**TOWN OF NEWBURGH
PLANNING BOARD
TECHNICAL REVIEW COMMENTS**

PROJECT: GARDNERTOWN COMMONS
PROJECT NO.: 2016-03
PROJECT LOCATION: SECTION 75, BLOCK 1, LOT 21
REVIEW DATE: 28 APRIL 2017
MEETING DATE: 4 MAY 2017
PROJECT REPRESENTATIVE: JCM PLANNING ENGINEERING

RE: JMC Project 15155
 Gardnertown Commons
 Gardnertown Road
 Town of Newburgh, NY

SP-11

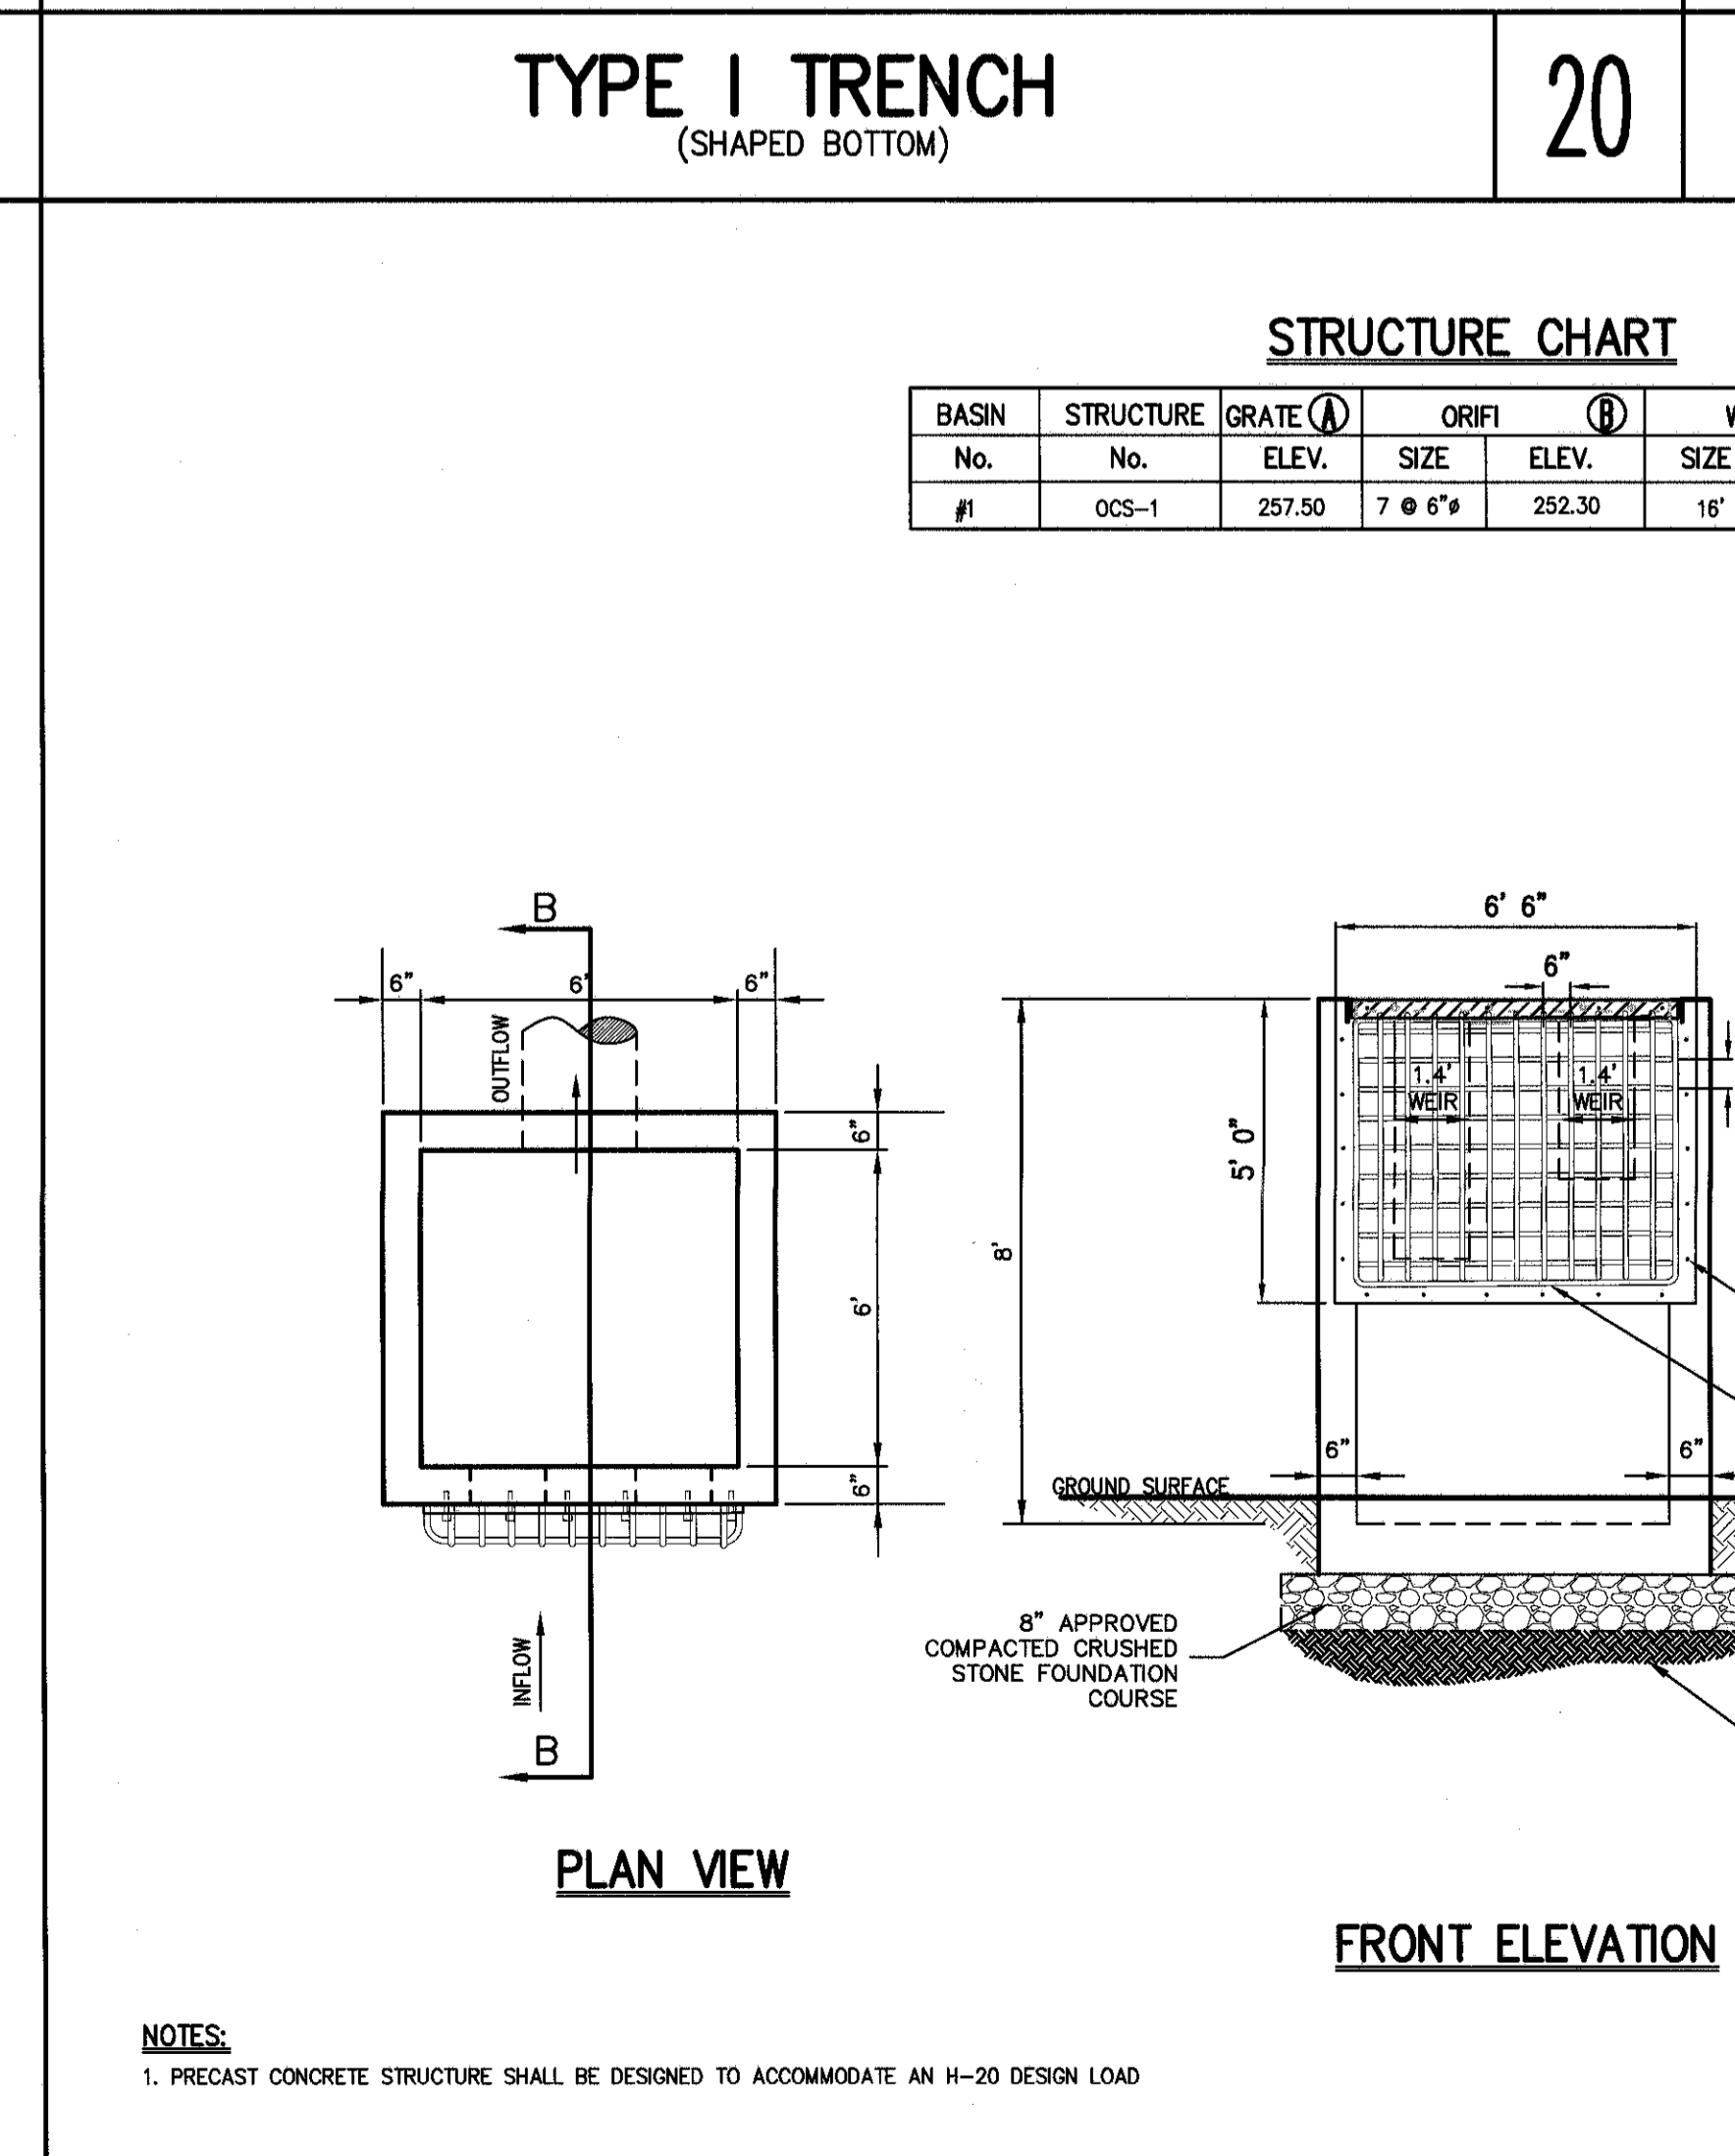
- j. *Anti vortex riser detail references a table for sizing of the devices. Location of this table should be noted.*

Detail #3 on Sheet SP-11 now has a table listing the sizing of the temporary riser & anti-vortex devices.
